FORD 4R100 NEW DESIGN SUN SHELL

02-16 Page 1 of 4

Figure 1
AUTOMATIC TRANSMISSION SERVICE GROUP

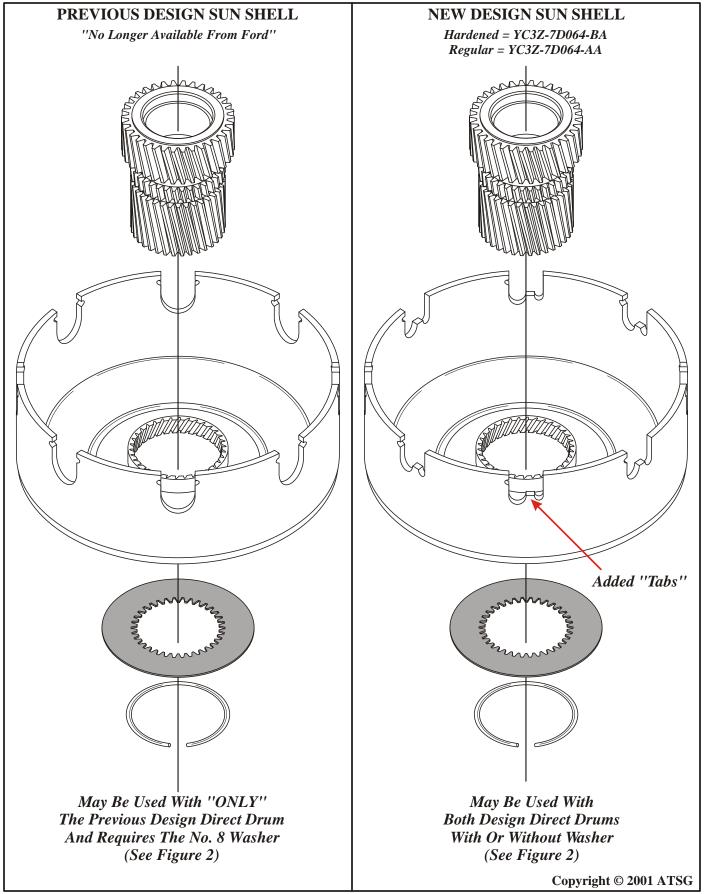
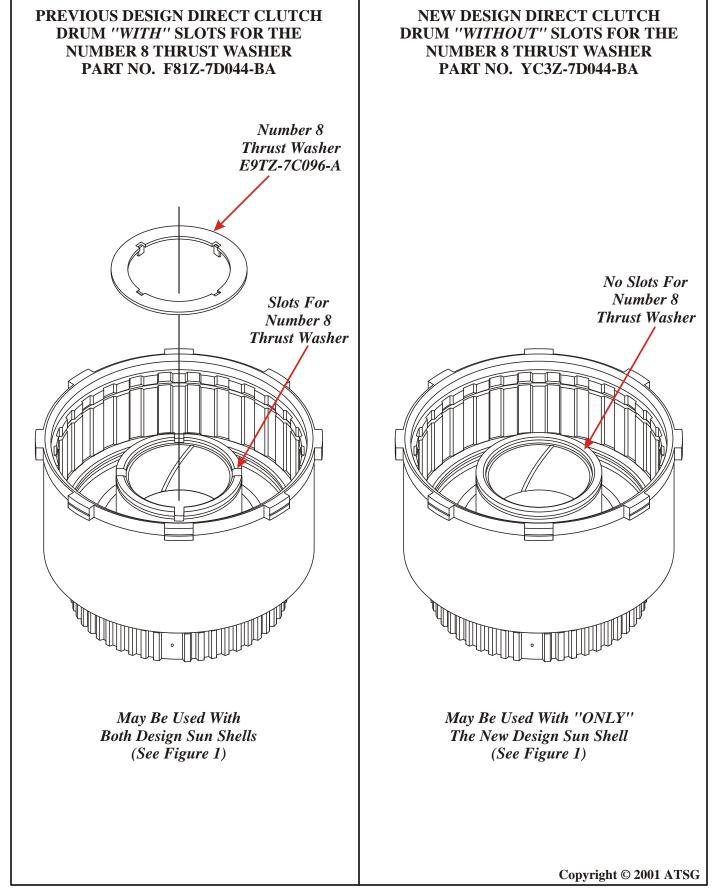
CHANGE: There is now a new design Sun Shell with "Tabs" added to the center of the sun shell slots, as shown in Figure 1, implemented by Ford Motor Co. as a running change, during the 2000 model year. This change eliminated the need for the number 8 thrust washer between the forward and direct drums. This also required a new installation tool for the assembly process.

- (1) INPUT SUN SHELL New design have "Tabs" added to the center of the sun shell slots, as shown in Figure 1, which now support the direct drum for the required clearance between the direct and forward clutch housings, and allows elimination of the number 8 thrust washer.
- (2) DIRECT CLUTCH HOUSING Manufactured "Without" slots in the center hub, as they were no longer needed to accept the number 8 thrust washer tabs. Both design direct drums are illustrated in Figure 2.
- (3) NUMBER 8 THRUST WASHER Eliminated (See Figure 2).
- (4) INSTALLATION TOOL New tool required for installation, to accommodate the changes in the sun shell slots and works with both design sun shells, as shown in Figure 3.

The 1st design Sun Shell is no longer available from Ford Motor Co, as the 2nd design Sun Shell *will* retro-fit back on all models, with or without the number 8 thrust washer.

The 2nd design Direct Clutch Housing (No Slots For Washer) *must* be used with the 2nd design Sun Shell, as there are no accommodations for the number 8 thrust washer.

NEW DESIGN LOADING TOOL

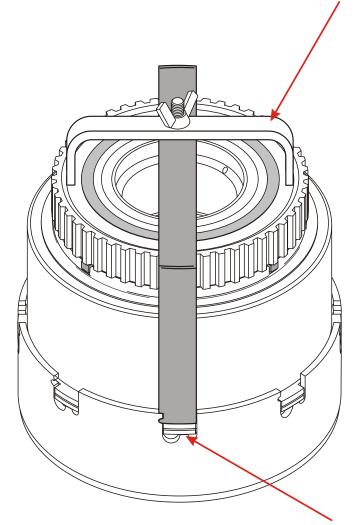
New Design Loading Tool Works On Both Sun Shells Available From Ford Motor Co. Under Part Number 307-436

Lugs On Direct Clutch Housing Now Supported By "Tabs" Added To Center of Sun Shell Slots Which Allowed Elimination Of The Number 8 Thrust Washer
